APPENDIX 6

Comments and Responses on Proposed 2016 Monitoring Network Plan, Revision 0

COMMENTS AND RESPONSES ON
PROPOSED 2016 MONITORING NETWORK PLAN, REVISION 0

The public comment period for the proposed 2016 Missouri Monitoring Network Plan opened on May 27, 2016 and closed on June 28, 2016. The Missouri Department of Natural Resources' Air Pollution Control Program prepared the 2016 Monitoring Network Plan to address the requirements of 40 CFR 58.10 (a) (1) for annual submittal of a plan to provide information on current State or Local Air Monitoring Stations (SLAMS), other ambient air monitoring, and any proposed network changes for the upcoming year.

Figure 6. Expected peak SO₂ concentration areas per DNR's modeling using KSUS instead of KJEF surface meteorological data.

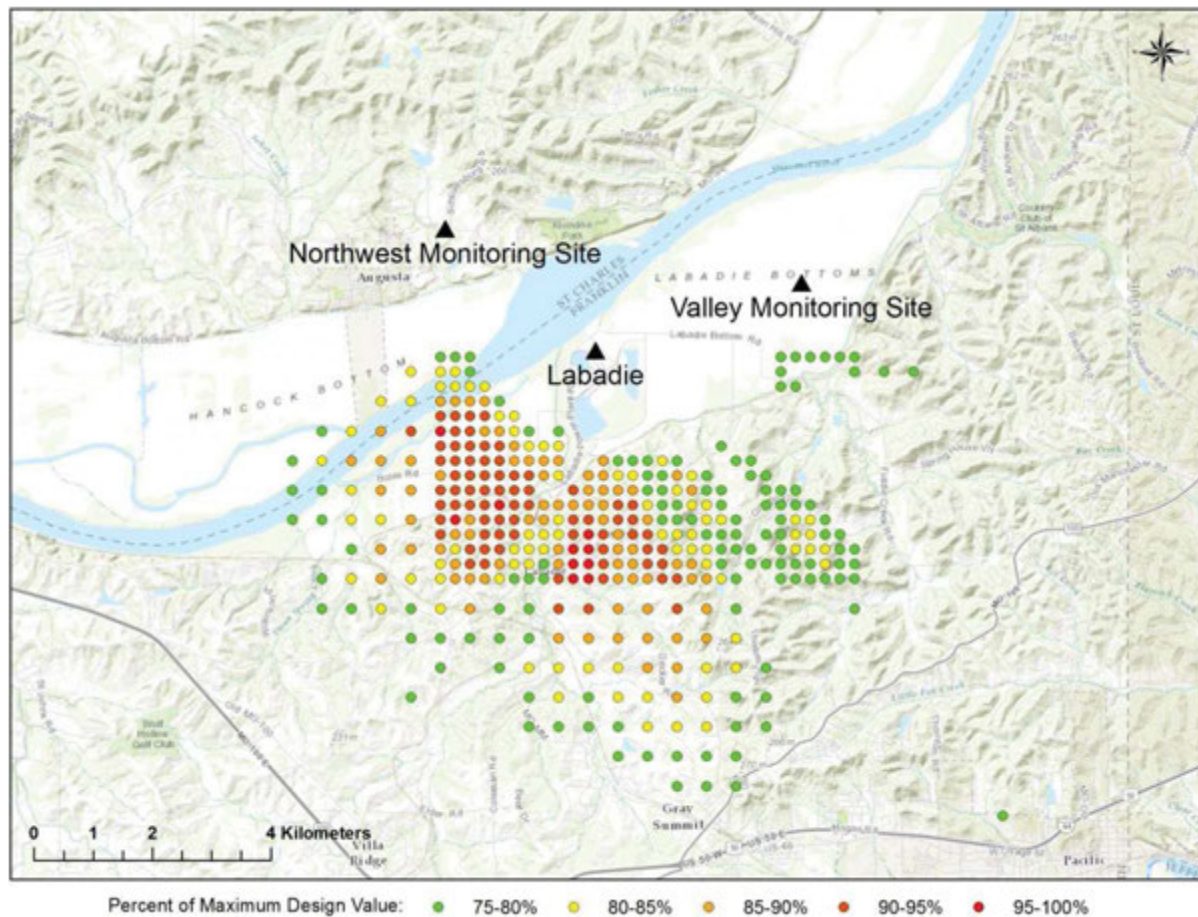
Figure 6 (see next page) shows peak concentration areas, demarcated by orange and red receptors, predicted by DNR's model when KSUS surface meteorological data is used instead of KJEF data. The results are striking; *if KSUS data is in fact more representative of the area than KJEF data, then neither the Valley monitoring site nor the Northwest monitoring site is located in an area where peak SO₂ concentrations are expected to occur and neither is appropriately sited for use in future NAAQS compliance evaluations.*

Figure 1. Modeled SO₂ design values in the vicinity of the Rush Island Energy Center.

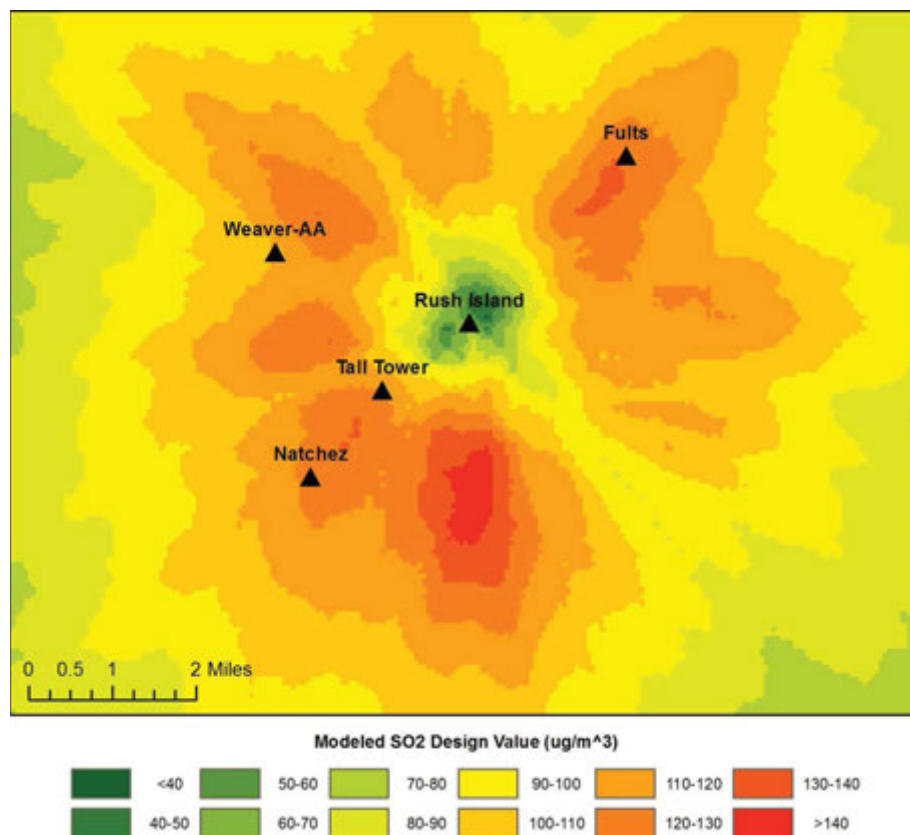
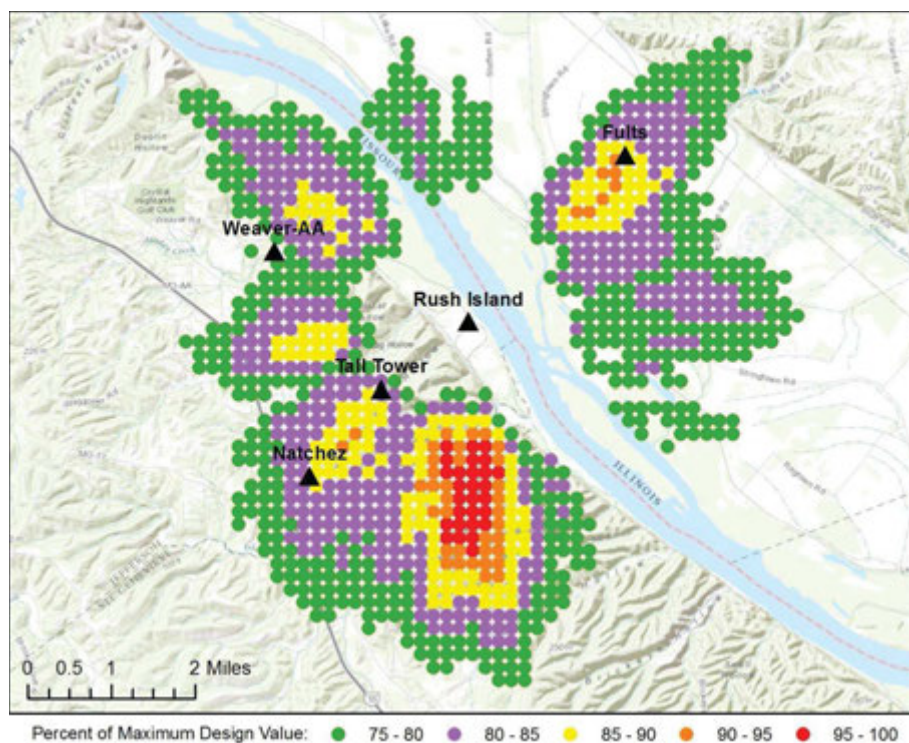
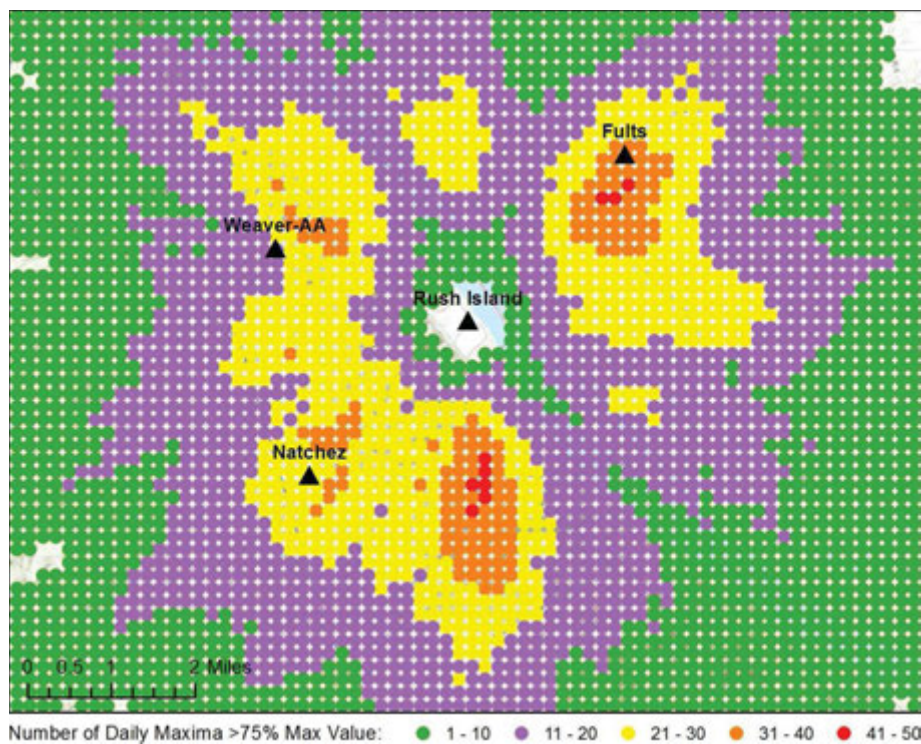
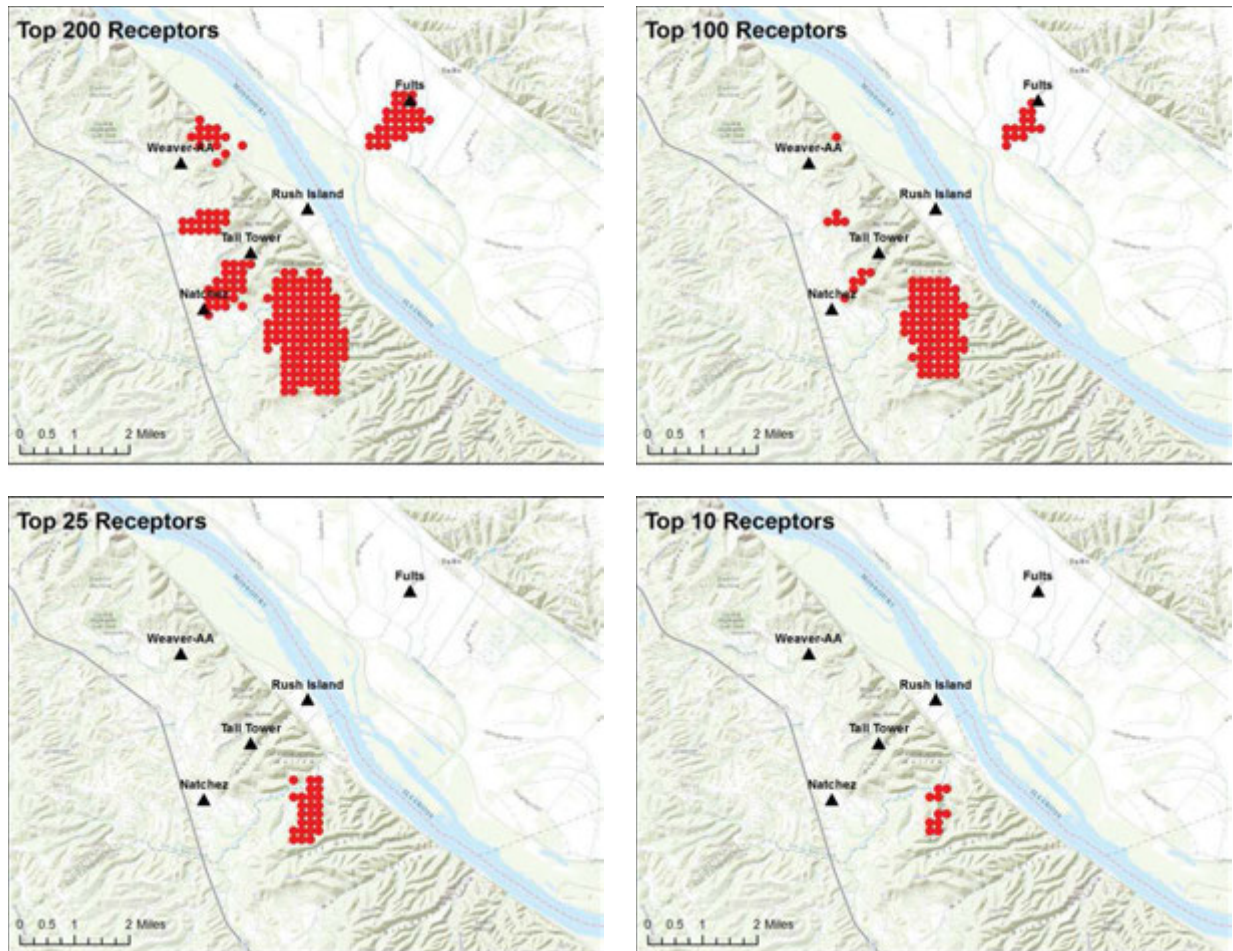
Figures 1 through 4 below show the results of Ameren’s modeling, which we derived using model input files provided by DNR. Figure 1 shows modeled SO₂ design values in the vicinity of the plant; Figure 2 shows receptors with modeled design values greater than or equal to 75 percent of the maximum modeled design value (146.1 ug/m³); Figure 3 shows the number of times the model-derived maximum daily 1-hour concentration exceeded 75 percent of the maximum modeled design value at each receptor; and Figure 4 shows the receptors with the top 200, 100, 25, and 10 modeled design values. The locations of the plant and the proposed Fults, Natchez, and Weaver-AA SO₂ monitoring stations and the proposed Tall Tower meteorological monitoring station are shown on all figures for reference.

Figures 1 through 4 all reveal a strikingly similar pattern regarding the areas where peak 1-hour SO_2 concentrations are expected to occur around the Rush Island Energy Center. There is a large area due south of the plant where modeled design values are the highest (in excess of 95 percent of the maximum modeled design value), where modeled maximum daily 1-hour concentrations frequently exceeded 75 percent of the maximum modeled design value, and where over half of the top 200 receptors (including all of the top 25 and three quarters of the top 100) are located. There are also four other areas where modeled design values are slightly lower but still very high (in excess of 85 percent of the maximum modeled design value), where modeled maximum daily 1-hour concentrations frequently exceeded 75 percent of the maximum modeled design value, and where the rest of the top 200 receptors are located. These four areas, located northeast, northwest, west, and southwest of the plant, plus the area south of the plant where modeled design values are the highest, are where Ameren's modeling predicts peak 1-hour SO_2 concentrations are expected to occur. Monitoring stations located in these areas would have the greatest chance of identifying peak SO_2 concentrations in ambient air, which is the primary objective of source-oriented monitoring and an absolute necessity when monitoring to assess

Figure 6. Current and optimized locations of the Fults, Natchez, and Weaver-AA monitoring stations

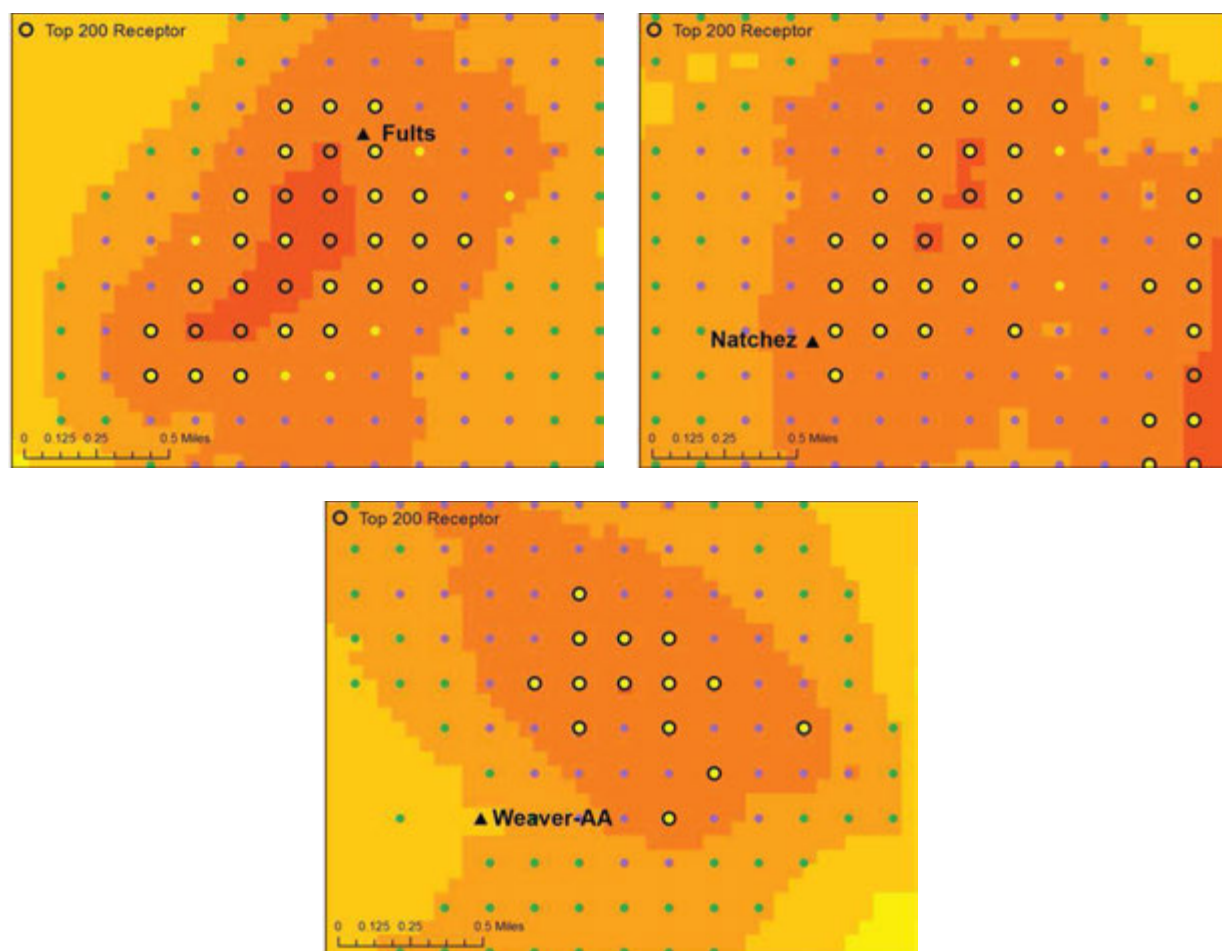
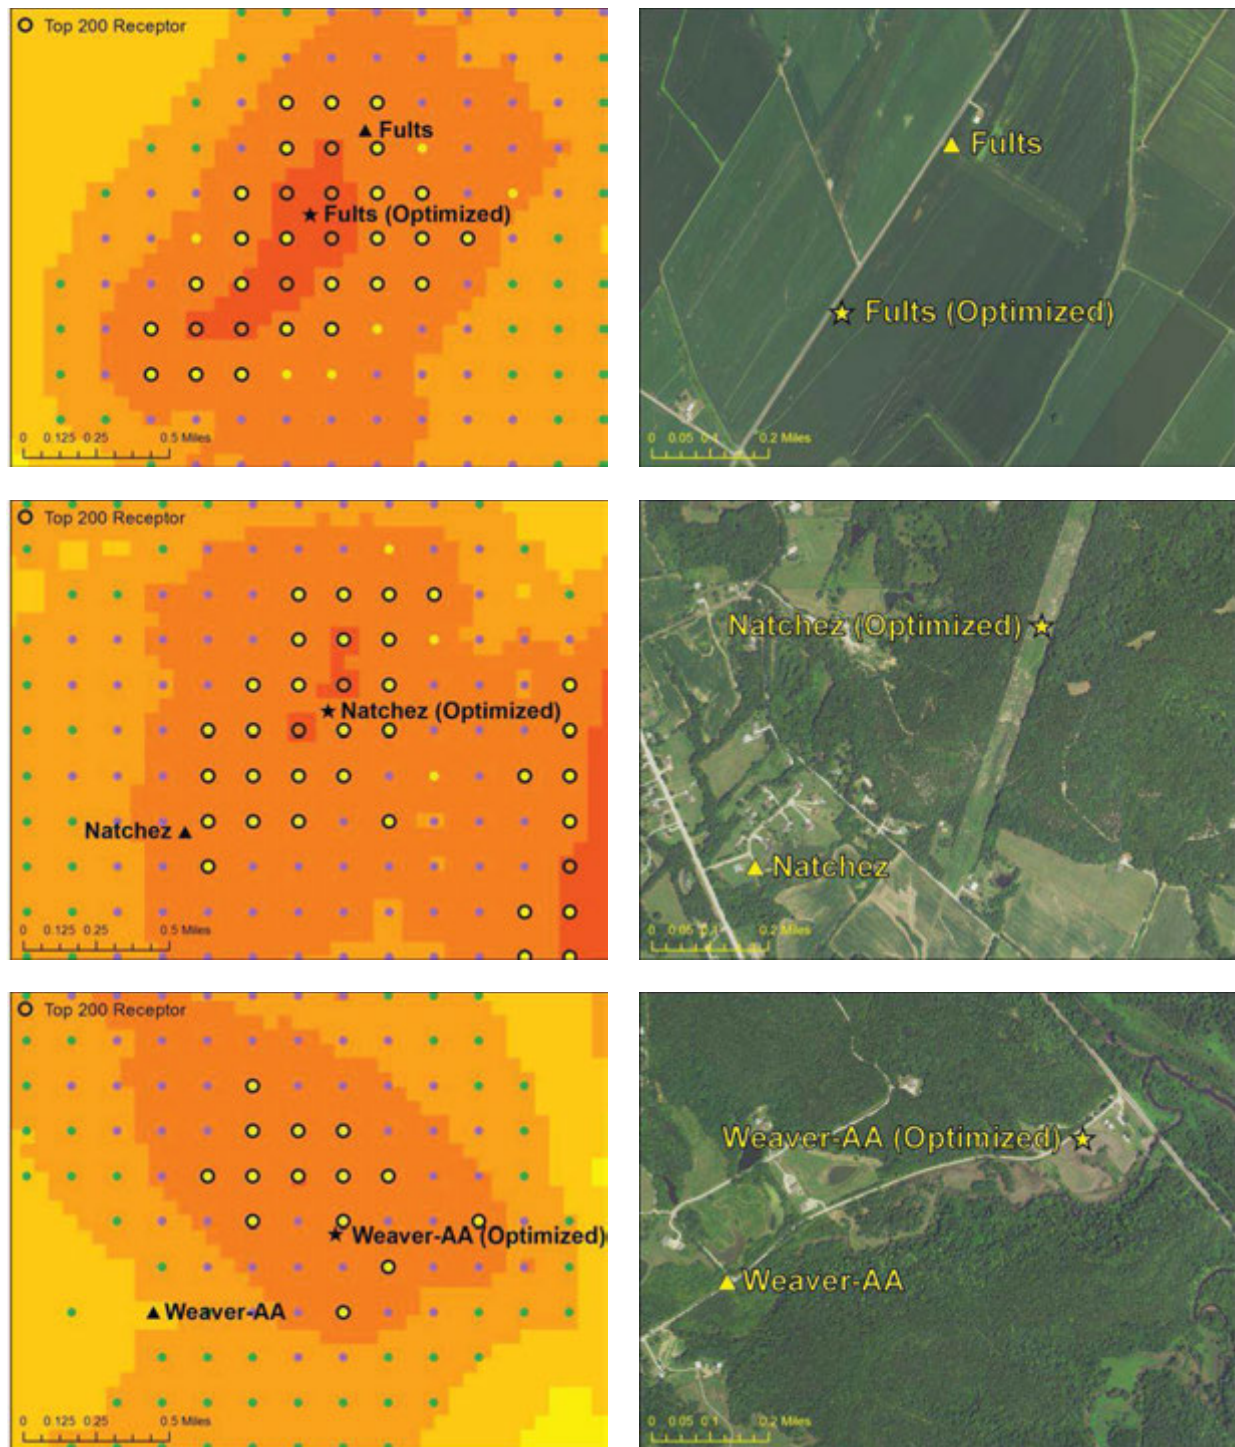
Furthermore, two of the proposed monitoring stations – Fults and Natchez – are located near but outside of areas of modeled peak concentration/high frequency instead of near the center of such areas, where concentrations are expected to be higher. The third proposed station – Weaver-AA – is located entirely outside of modeled peak concentration/high frequency areas. Figure 5 shows the locations of the proposed monitoring stations on a hybrid basemap comprised of Figures 1 (modeled design values) and 2 (receptors with modeled design values ≥ 75 percent of the maximum design value). Receptors that are among the 200 with the highest modeled design values are outlined for reference. All three monitoring stations could easily be sited in areas where higher 1-hour SO₂ concentrations are expected to occur with greater frequency, thereby increasing their chances of detecting any NAAQS exceedances that might occur around the Rush Island Energy Center. As discussed below, we urge DNR to consider these proposed optimized locations in lieu of Ameren's proposed Fults, Natchez, and Weaver-AA locations.

Figure 6 compares the locations of Ameren’s proposed Fults, Natchez, and Weaver-AA monitoring stations with optimized locations more likely to record maximum SO₂ concentrations in the area.
